# Manual 15, Cost Development Guidelines

Market Implementation Committee  
August 6, 2025

**Revision 47 (10/01/2025):****All changes are conforming to Regulation Redesign Phase I**

*Exhibit 3: Regulation Maximum Allowable Cost Adder Example*

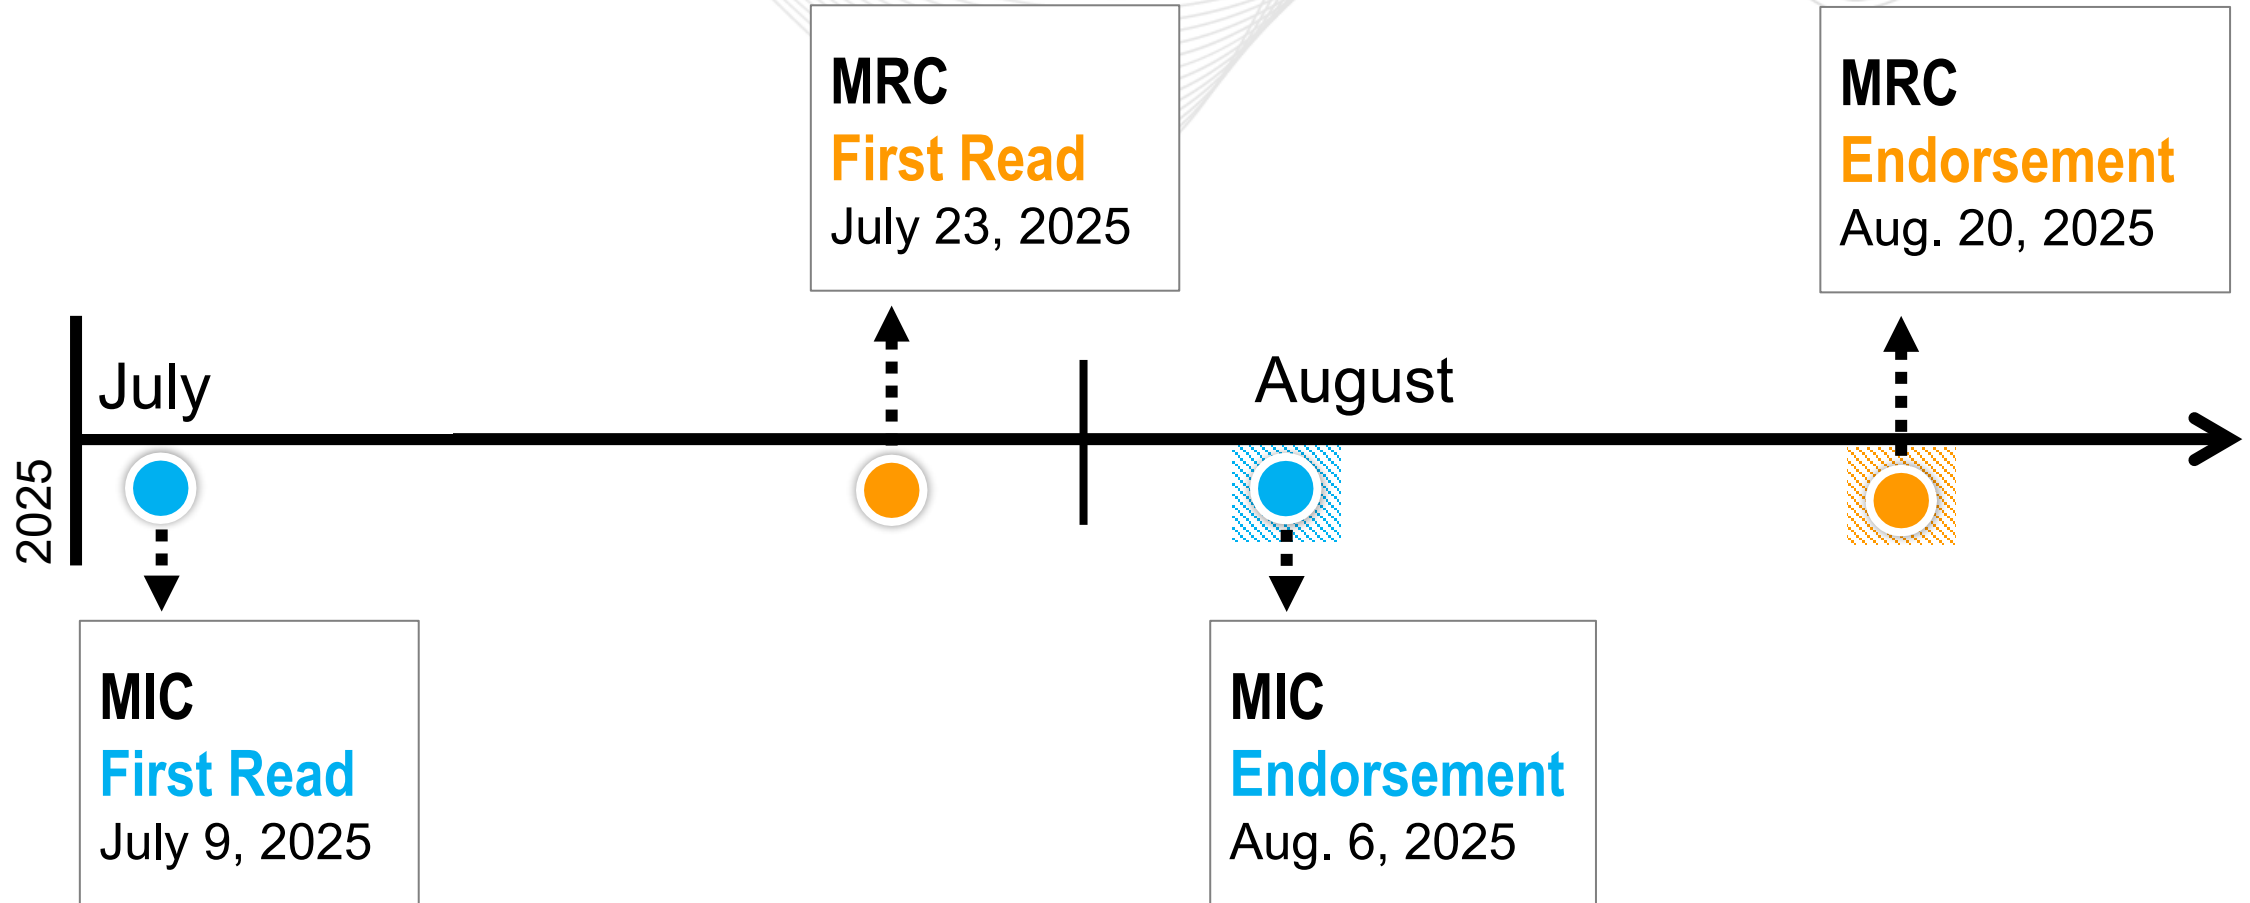
- Section 2.8:
  - Updated calculated value for Exhibit 3: Regulation Maximum Allowable Cost Adder Example

<i>FuelCostAdder =</i>
<i>[\$0.50 / Hr / MW + \$0 / Hr / MW] / 5 Δ MW / MW = \$0.10 / Hr / MW of Regulation</i>
